**Review of Sandia National Laboratories'
Mixed Waste Landfill Corrective Measure Implementation Plan
and Fate and Transport Model:**

Comments and Recommendations

February 7, 2006

Prepared by
Paul Robinson
Research Director
Southwest Research and Information Center
PO Box 4524
Albuquerque, NM 87106
sricpaul@earthlink.net
505-262-1862

Figure 22. Simulated PCE groundwater concentrations for 100 realizations.

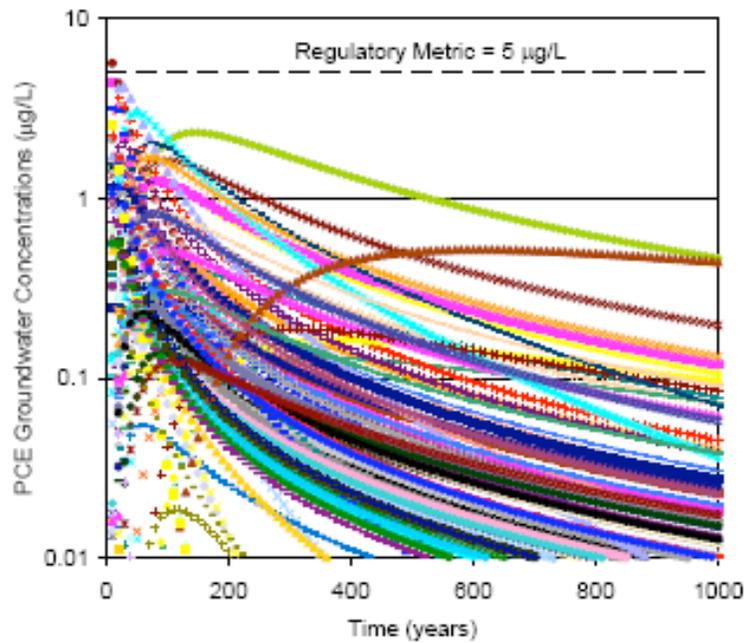
“Figure 22 [on p. 55] shows the simulated PCE concentrations in the groundwater as a function of time for all 100 realizations. **The majority of the realizations show the aquifer concentrations peaking before 50 years. Depending on the time of disposal, this corresponds to peak concentrations occurring by 2010 – 2040.** [emphasis added]. To date, no detectable amounts of PCE have been found in the groundwater at the MWL. This is still consistent with the simulations which show a large amount of variability in the simulated concentrations resulting from uncertainty included in the input parameters.” FTM at pp. 54-55. Figure 22 is attached these comments as APPENDIX A.

Thus, the FTM confirms that a volatile organic compound already shown to have escaped from the MWL, tetrachloroethylene (PCE), is likely to reach the groundwater aquifer within 50 years in most model runs. This finding should serve as a basis for NMED to focus a substantially higher degree of attention on the need for a corrective measure at the MWL that can be demonstrated to effectively control releases of VOCs.

RECOMMENDATION: Because PCE was shown to reach groundwater in all model realizations within approximately 50 years, the FTM should be revised to include model realizations reflecting future movement of all VOCs and SVOCs found to have been released from the landfill in 1993. These additional models and model realizations should be revised to include consideration of the decay products of PCE and the other VOCs and SVOCs that were shown to have escaped the MWL by 1993. Decay products modeled should include any decay products, such as vinyl chloride, that may have MCLs as low or lower than that established for PCE.

Figure 23. Cumulative probability for simulated PCE peak groundwater concentrations for 100 realizations.

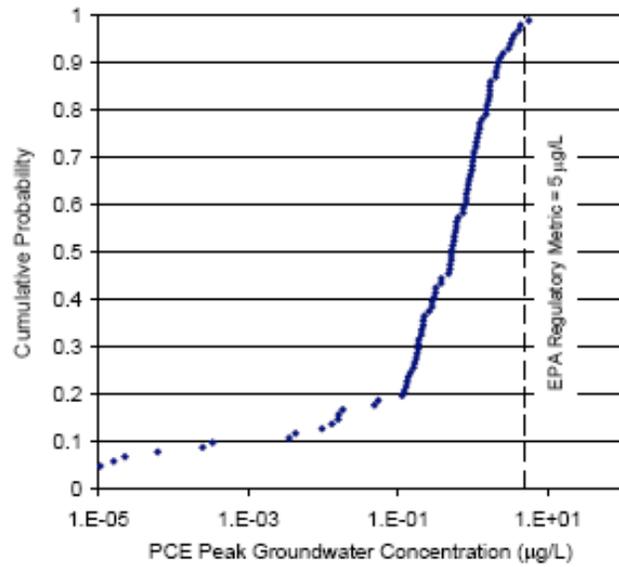
Figure 23 in the FTM shows the concentration of PCE anticipated in the groundwater by the model realizations. This figure shows that the vast majority of the realizations – about 80% - show PCE levels in the groundwater in the range of 1 – 5 micrograms per liter, equivalent to parts per billion. Prediction of those concentrations of PCE reaching the groundwater represent a prediction of significant contamination as PCE is not naturally occurring and therefore **zero** PCE would be predicted to have reached groundwater if no PCE were already shown to have escaped from the MWL. Figure 23 is attached to these comments in APPENDIX A.
